ARLINGTON COUNTY, VIRGINIA

County Board Agenda Item Meeting of September 17, 2005

SUBJECT: Adoption of proposed amendments to Section 20 (Appendix A) "CP-FBC"
Columbia Pike - Form Based Code Districts of the Zoning Ordinance to:

B. Building Envelope Standards: Main Street Sites

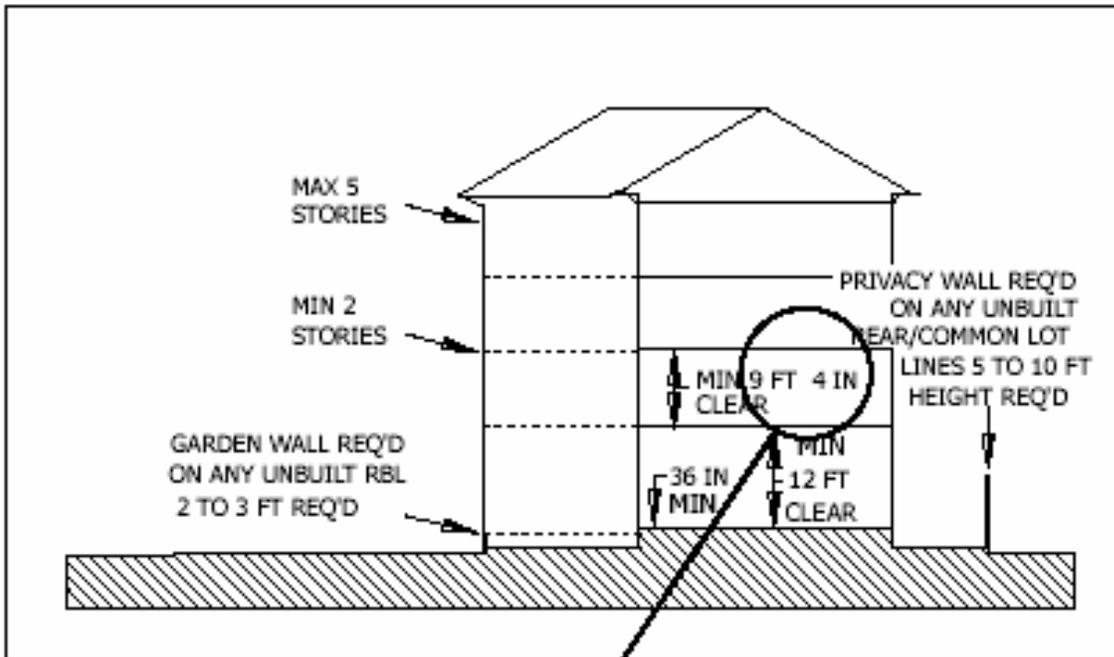
Proposed change: 9 feet clear for upper STORIES except uppermost STORY which shall have a minimum clear height of 10 feet.
